A46 Newark Bypass

7.68 Comments on submissions received at the previous deadline

The A46 Newark Bypass
Development Consent Order 202[x]

Comments on submissions received at the previous deadline

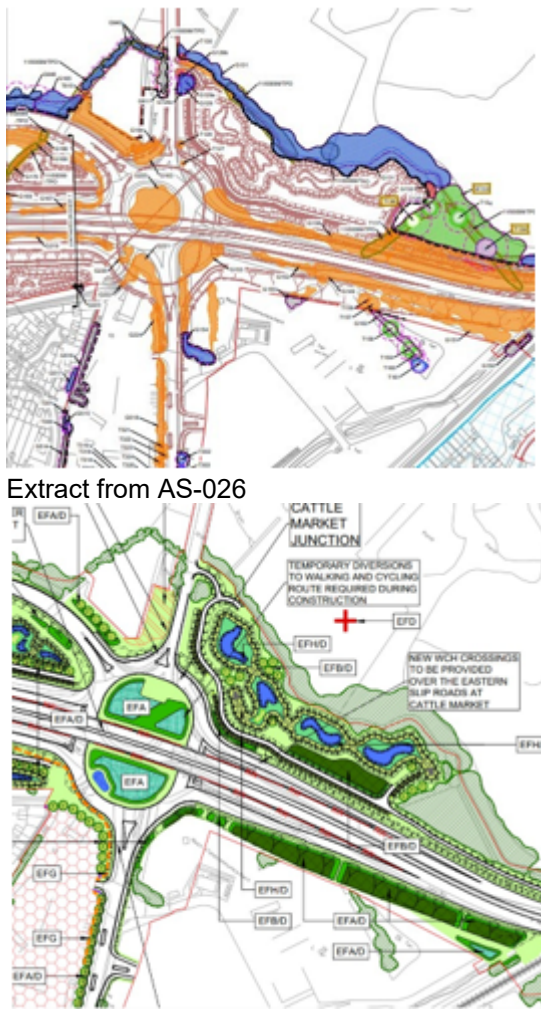
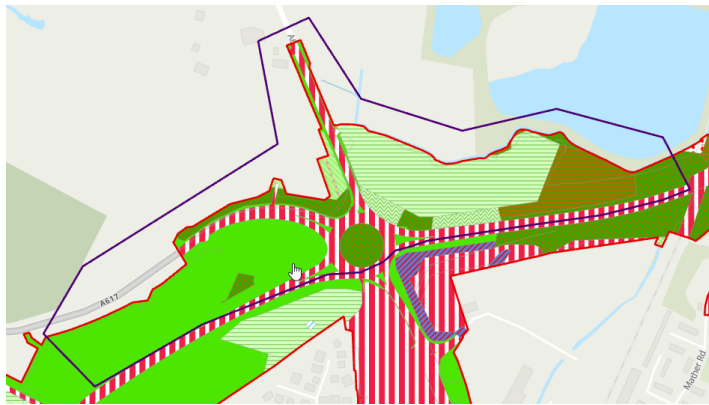
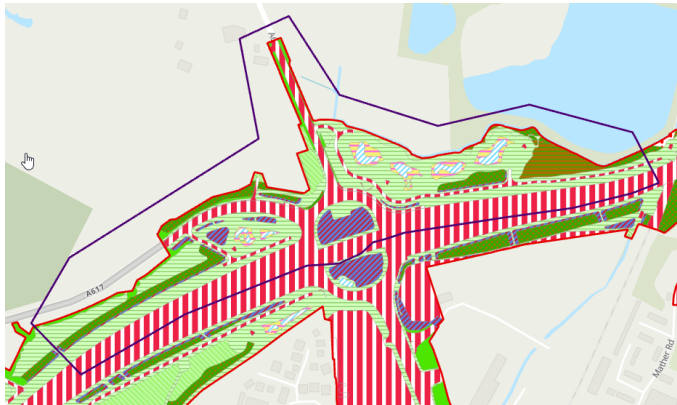
David Corden Response	The Applicant Response
<p>Hi. I live on [REDACTED] a quarter of a mile from the Farndon Island, and I would like to make an observation about the proposed Farndon Island works. Having read your documentation I am aware that there will be a traffic light system and that the island will be widened, all of which I am in support of. However, I don't believe that the document details (to date) properly address the road noise to neighbouring streets. I would like to recommend that,</p> <ol style="list-style-type: none">1) noise cancelling road surfaces are used,2) some form of (cosmetically appealing) noise deflection barriers are used on the southerly approach to the Farndon Island and for the island itself to deflect noise (effectively from the River Devon to the island,3) that such an approach include raised earth embankments.4) There is also an abundance of land around this island approach which could be planted with trees, to further aid noise reduction. This could include tree lining the Farndon Road itself, from the island. This would make this popular approach to Newark more visually appealing.5) If the speed of approaching traffic to the island could be mitigated then that may also assist, however, I suspect that the new traffic lights may solve this problem. Thank you for your consideration, and for making the noise associated with this road / island less of a nuisance for residents.	<p>The Applicant has assessed the impacts associated with the Scheme and, where required, mitigation has been provided. As a publicly funded scheme the Applicant is not able to undertake works that are not required as a direct impact of the Scheme. Scheme proposals including essential mitigation are therefore restricted to the Order Limits, which have been established as a result of the design development and environmental assessment work. The Scheme Order Limits are shown on Figure 1.1 (Scheme Draft Order Limits) of the Environmental Statement Figures [AS-023].</p> <p>The Applicant confirms suitable noise mitigation measures considering potential physical constraints will be provided along the Scheme which will include standard height parapets with infill panels along the west side of the proposed Windmill viaduct and the east side of the existing Windmill viaduct. It is noted that the parapet along the western side of the viaduct will extend further south towards Farndon Roundabout, transitioning in form into a 2 metre noise barrier. No further noise screening is proposed in the southern approach to Farndon Roundabout to address operational noise as the associated assessment in Chapter 11 (Noise and Vibration) of the Environmental Statement [APP-055] did not identify noise impacts with the potential to lead to a significant effect.</p> <p>The Applicant has also addressed each of the five listed points raised in the Interested Party's submission:</p> <ol style="list-style-type: none">1) Low-noise road surfacing will be provided throughout the Scheme. Low noise road surfacing is already present on the northbound approach to Farndon Roundabout and around the roundabout itself.2) The landscape and visual impact assessment of the Scheme (documented in Chapter 7 (Landscape and Visual Effects) of the Environmental Statement [APP-051]) did not identify any mitigation works required adjacent to the existing northbound approach to Farndon Roundabout and all existing vegetation is retained. Details of this mitigation can be seen in Sheet 1 of Figure 2.3 (Environmental Masterplan) of the Environmental Statement Figures [AS-026]. <p>Extract from Sheet 1 of Figure 2.3:</p>

<p>Operational noise impacts of the Scheme are adverse in some areas and beneficial in others but none of these are anticipated to be significant with the proposed mitigation in place; the assessment for noise is documented in Chapter 11 (Noise and Vibration) of the Environmental Statement [APP-055]. Sheet 7 of Figure 11.9 (Short-term Noise Change) [AS-063] and Figure 11.10 (Long-term Noise Change) of the Environmental Statement Figures [AS-064] show that the impact in the short-term and long-term respectively in the Farndon area is predominantly negligible or minor, depending upon the exact location in relation to the Scheme. It is therefore not possible to justify the installation of additional noise barriers as suggested.</p> <p>Requirement 16 of the draft Development Consent Order [APP-021] secures the provision of the noise mitigation measures presented within Chapter 11 (Noise and Vibration) of the Environmental Statement [APP-055] which includes the measures shown on Figure 2.3 Environmental Masterplan of the Environmental Statement Figures [AS-026].</p> <ol style="list-style-type: none">3) Similarly, the outputs of assessments documented in Chapter 11 (Noise and Vibration) of the Environmental Statement [APP-055] and Chapter 7 (Landscape and Visual Effects) of the Environmental Statement [APP-051] have not resulted in the need to propose raised earth embankments along the approaches to Farndon Roundabout. It is therefore not possible to justify the installation of additional raised earth embankments as suggested.4) Given the limited change in visual amenity arising from the roundabout itself, new swathes of planting are not considered as being required from the perspective of essential mitigation. However, existing vegetation would be retained on the approach to Farndon Roundabout, with a small area of new replacement planting proposed to the north western extents when exiting the roundabout heading north on the A46.5) The Permanent Speed Limit Plans [AS-014] show a 40mph limit on the approach Farndon roundabout which will reduce speeds on the approach to the roundabout.
